PRATT & WHITNEY CANADA  
**TOOL SERVICE BULLETIN**

NO: PW200-301

**Description:** Knocker

**Subject:** Tool Introduction

Figure 1

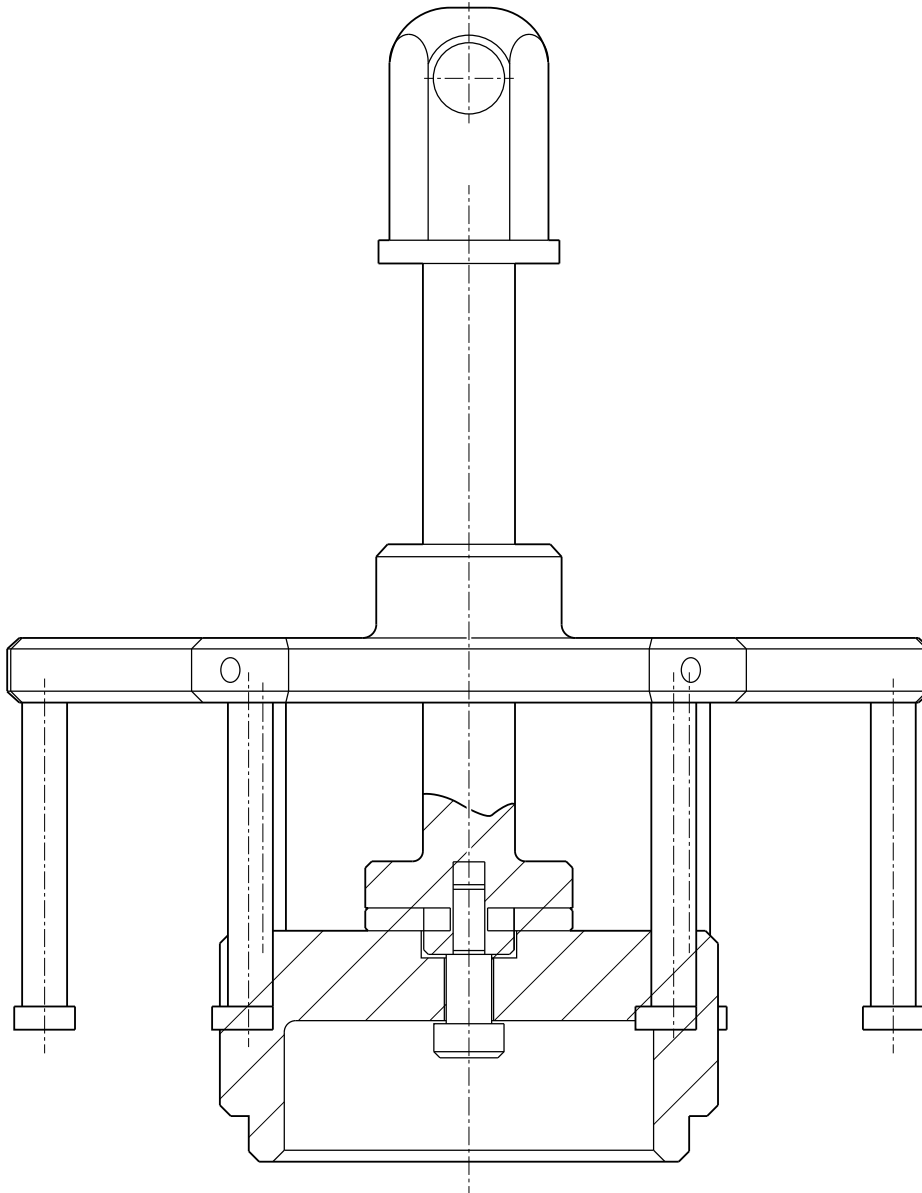
**Problem:** Tool PWC64018 may damage engine hardware.

**Cause:** Tool is used to pull the part at one location at a time.

**Instruction:** New tool PWC64840 is introduced to replace PWC64018 under section of the Overhaul Manual 72-03-00 and Engine Maintenance Manual 72-00-30 (CT Stator and Combustion Chamber Liners - Removal). Refer to Figure 1.

**Solution:** New tool PWC64840 introduced.
